Quantum™

To: T10 Technical committee
From: Mark Evans
Bruce Leshay
Phone: 408-894-4019
Fax: 408-952-3620
Email: mark.evans@quantum.com
Date: 07 March 2000

Subject: Proposal for training pattern protocol to be included in SPI-4

Figure x1 – Flow diagram for DT DATA IN training pattern before a DT DATA IN transfer

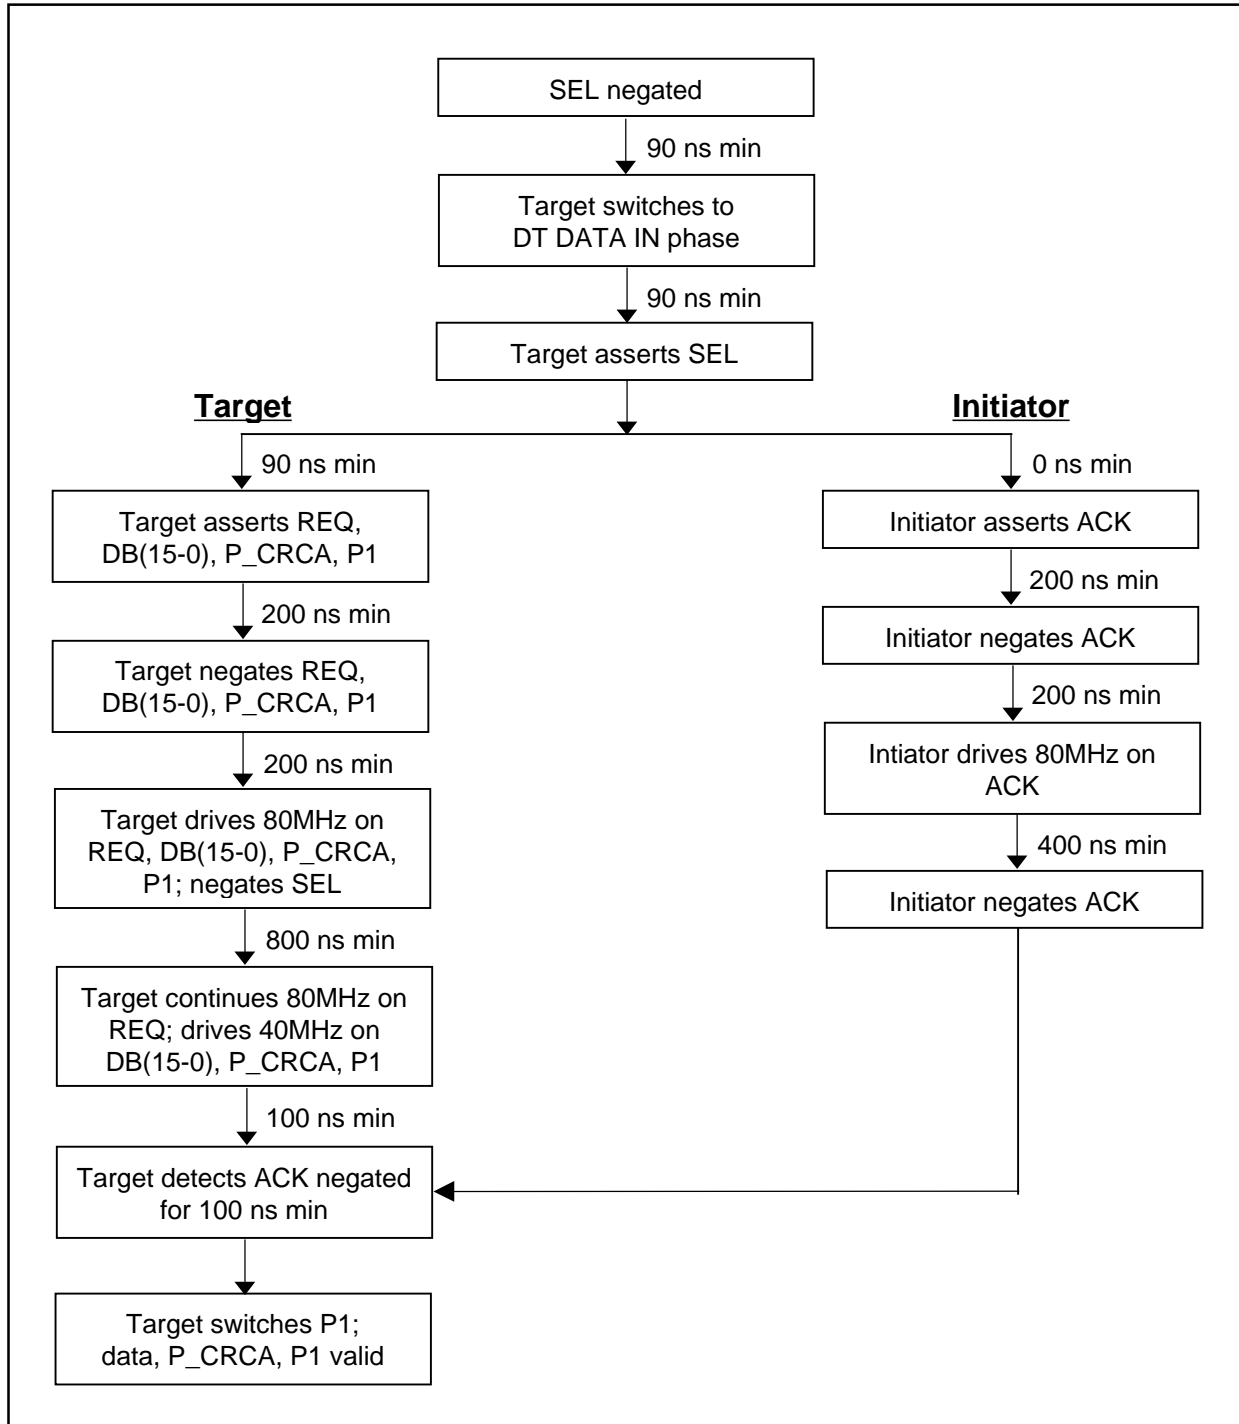
Following a selection or reselection, the target shall not transition to DT DATA IN phase for a training pattern sequence until at least two system deskew delays after it detects SEL negated. The target shall not initiate a training pattern sequence until at least two system deskew delays after transitioning to a DT DATA IN phase. The target shall initiate a training pattern sequence by asserting SEL. After asserting SEL, the target shall wait at least two system deskew delays and then assert REQ, DB(15-0), P0, and P1. The target shall wait at least initial training time and then negate REQ, DB(15-0), P0, and P1.

After negating REQ, DB(15-0), P0, and P1, the target shall wait at least one initial training time and then begin alternately asserting and negating REQ every (transfer period ÷ 2) ns (i.e., an alternating “101010...” pattern) and transmit the first transmitter training pattern by alternately asserting and negating DB(15-0), P0, and P1 every (transfer period ÷ 2) ns for at least one first transmitter training time. Assertion and negation of REQ, DB(15-0), P0, and P1 shall be in phase.

After transmitting the first transmitter training pattern for at least one first transmitter training time, the target shall transmit the second transmitter training pattern by alternately asserting and negating DB(15-0), P0, and P1 every (transfer period) ns (i.e., an alternating “110011001100...” pattern) for at least one second transmitter training time. Assertion and negation of REQ, DB(15-0), P0, and P1 shall be in phase. The target may test ACK.

After transmitting the second transmitter training pattern for at least one second transmitter training time, the target shall negate DB(15-0) and P0 for at least (transfer period × 2) ns. After negating DB(15-0) and P0 for at least (transfer period × 2) ns, the target shall test ACK.

If ACK is negated and this is a DT DATA IN training pattern before a DT DATA IN transfer, the target may begin transmitting data for the phase. If ACK is negated and this is a DT DATA IN training pattern after a PARALLEL PROTOCOL REQUEST message, the target shall negate REQ, release DB(15-0), P0, and P1, and switch to DT DATA OUT phase.

Figure x2 – Flow diagram for a DT DATA IN training pattern after a PARALLEL PROTOCOL REQUEST message

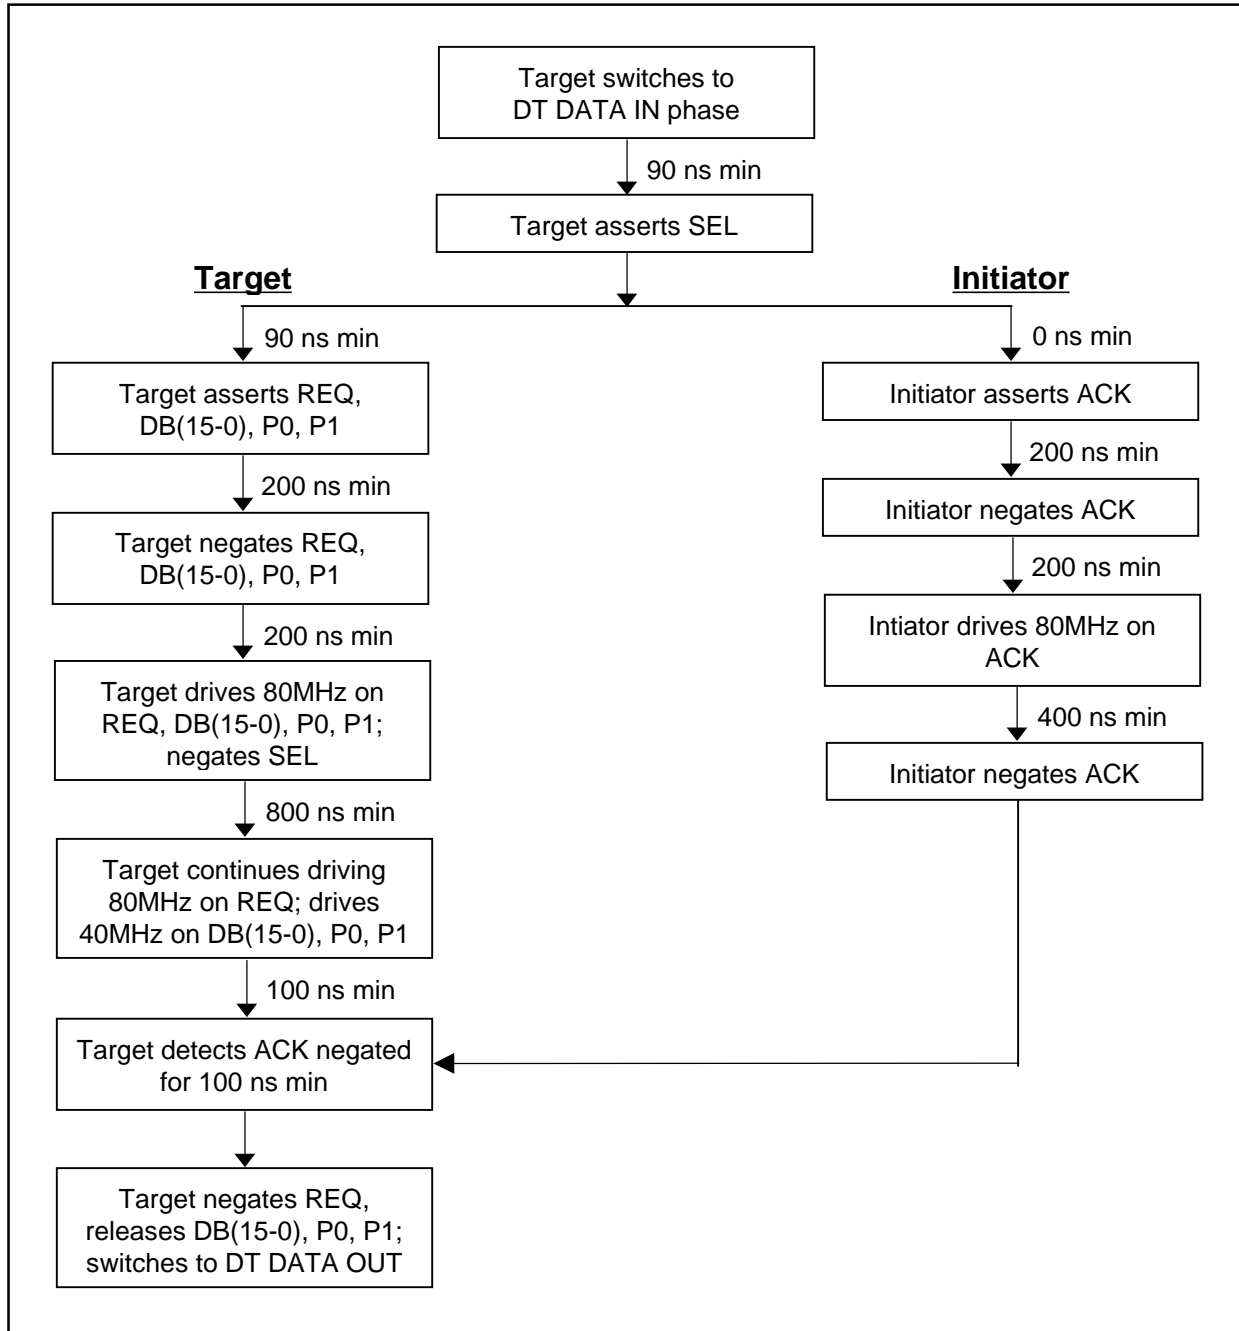
After detecting the assertion of SEL, the initiator shall assert ACK. After asserting ACK the initiator shall wait at least one initial training time and then negate ACK. After negating ACK the initiator shall wait at least one initial training time. The initiator shall then transmit a receiver training pattern by alternately asserting and negating ACK every $(\text{transfer period} \div 2)$ ns (i.e., an alternating "101010..." pattern) for at least one receiver training time. After alternately asserting and negating ACK for at least one receiver training time, the initiator shall negate ACK.

Figure x3 – Flow diagram for DT DATA OUT training pattern before a DT DATA OUT transfer

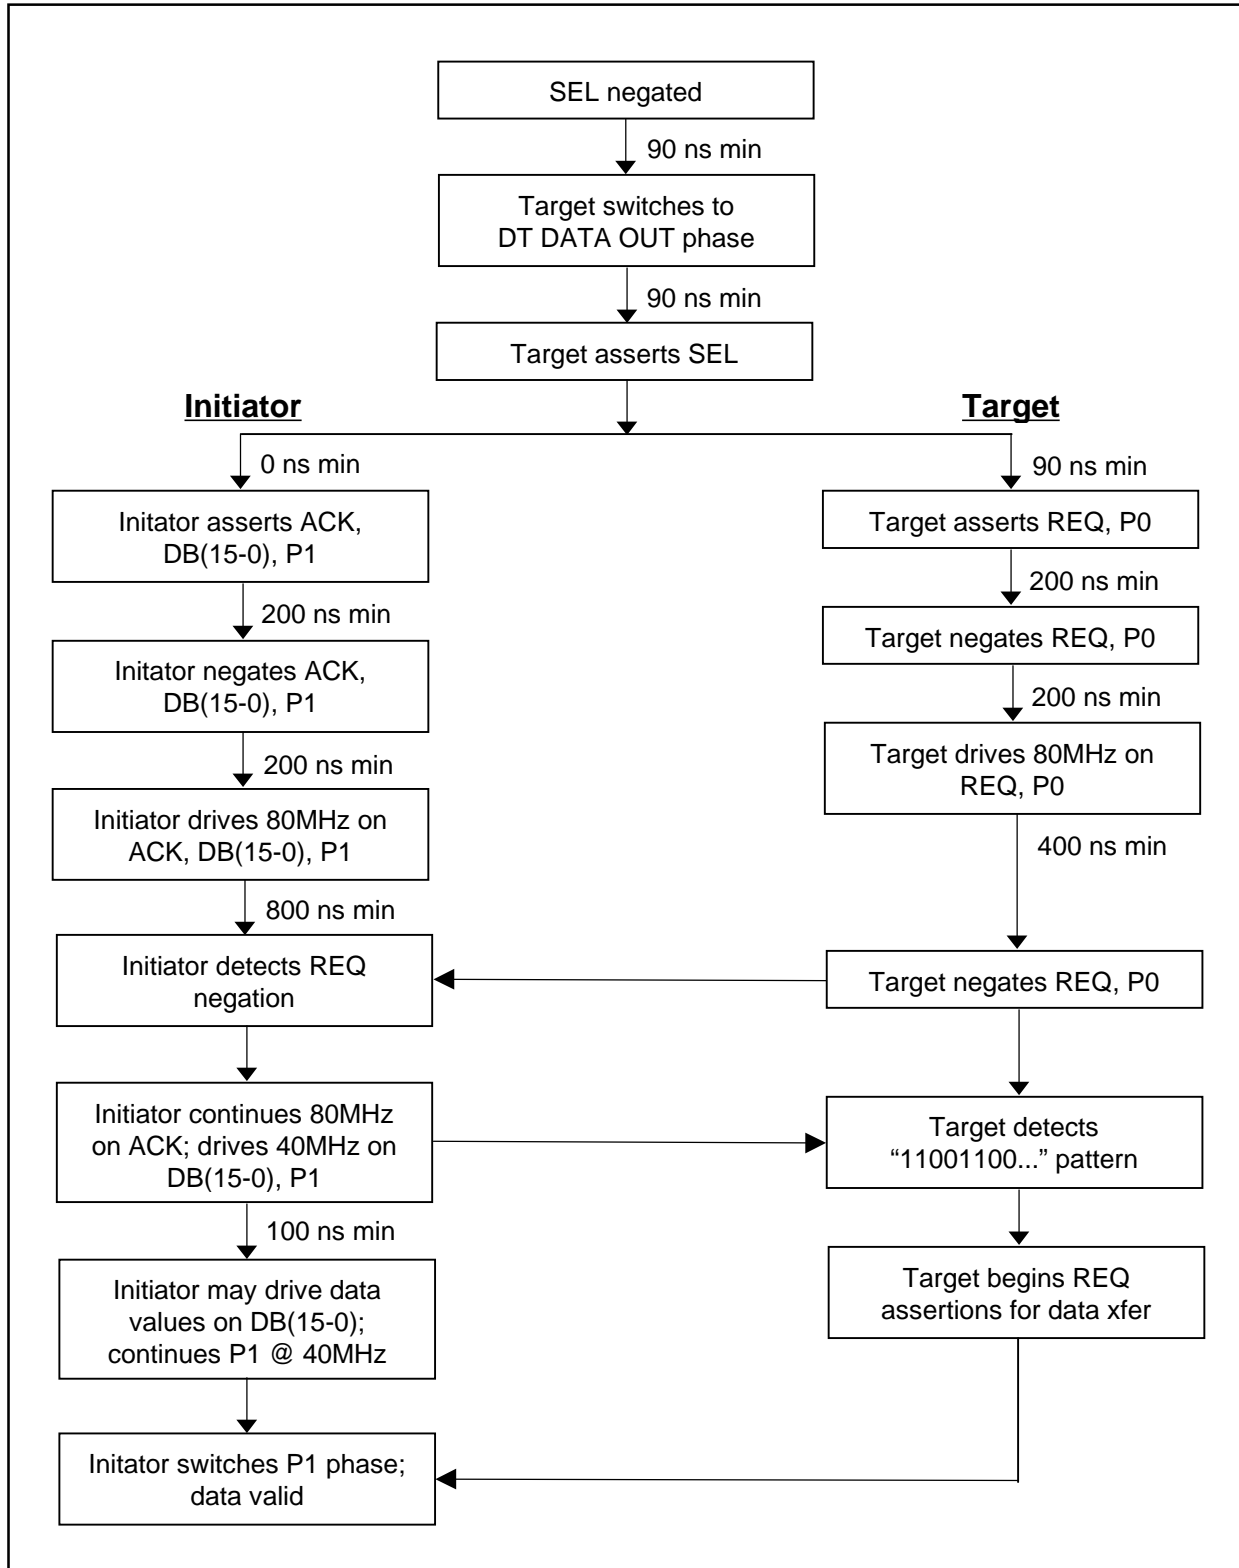
Following a selection or reselection, the target shall not transition to DT DATA OUT phase for a training pattern sequence until at least two system deskew delays after it detects SEL negated. The target shall not initiate a training pattern sequence until at least two system deskew delays after transitioning to a DT DATA OUT phase. The target shall initiate a training pattern sequence by asserting SEL. After asserting SEL, the target shall wait at least two system deskew delays and then assert REQ and P0. The target shall wait at least initial training time and then negate REQ and P0.

After negating REQ and P0, the target shall wait at least one initial training time and then transmit the receiver training pattern by alternately asserting and negating REQ and P0 every (transfer period ÷ 2) ns for at least one receiver training time. After alternately asserting and negating REQ and P0 for at least one receiver training time, the target shall negate REQ and P0. The target may negate SEL one initial training time after beginning the alternate assertion and negation of REQ and P0.

After negating ACK, DB(15-0), and P1, the initiator shall wait at least one initial training time and then begin alternately asserting and negating ACK every (transfer period ÷ 2) ns and transmit the first transmitter training pattern by alternately asserting and negating DB(15-0) and P1 every (transfer period ÷ 2) ns for at least one first transmitter training time. Assertion and negation of ACK, DB(15-0), and P1 shall be in phase.

The initiator shall continue to transmit the first transmitter training pattern for at least one first transmitter time or until detecting the negation of REQ for at least one system deskew delay after the receiver training pattern, whichever occurs last. After transmitting the first training pattern, the initiator shall transmit the second transmitter training pattern by alternately asserting and negating DB(15-0) and P1 every (transfer period) ns for at least one second transmitter training time. Assertion and negation of ACK, DB(15-0), and P1 shall be in phase. After transmitting the second training pattern for at least one second transmitter training time, the initiator may negate DB(15-0).

If this is a DT DATA OUT training pattern before a DT DATA OUT transfer, the target may begin transmitting REQ pulses for the data phase after detecting the initiation of the second transmitter training pattern on P1. The initiator may begin transferring data for the phase as soon as the second transmitter training pattern is complete and REQ pulses are detected from the target.

Figure x4 – Flow diagram for a DT DATA OUT training pattern after a DT DATA IN training pattern after a PARALLEL PROTOCOL REQUEST message

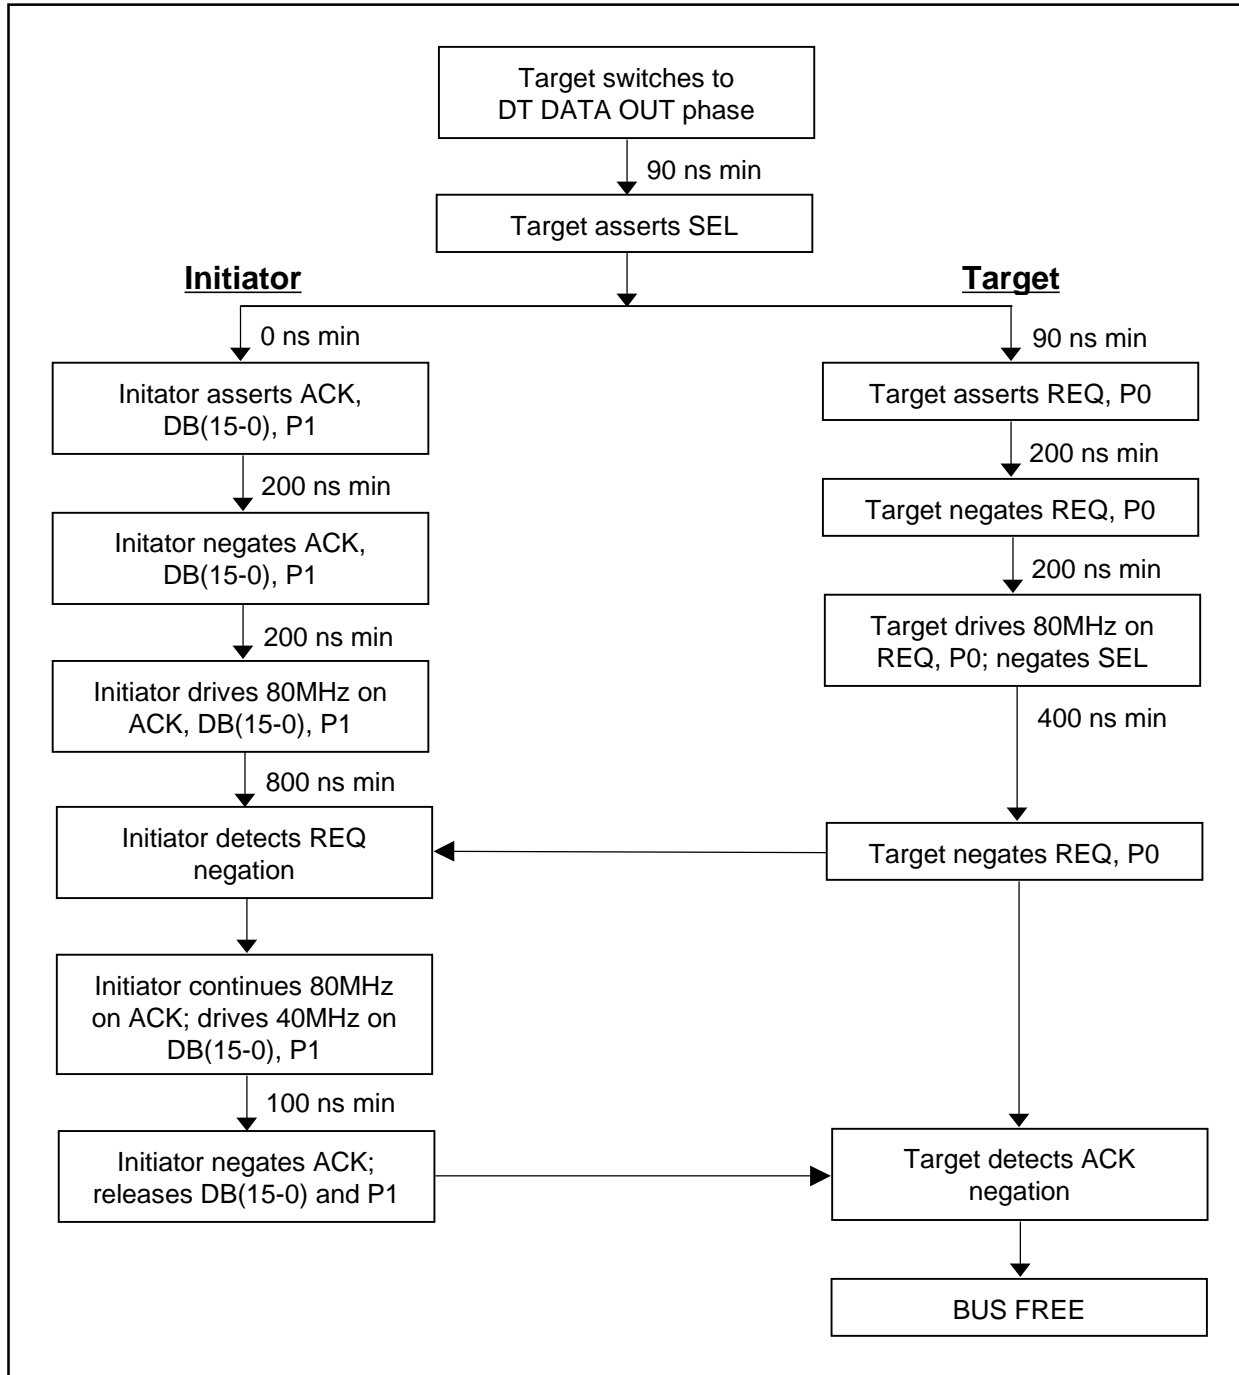
If this is a DT DATA OUT training pattern after a PARALLEL PROTOCOL REQUEST message, the initiator shall negate ACK, release DB(15-0) and P1. Upon detecting the negation of ACK, the target shall transition to BUS FREE.
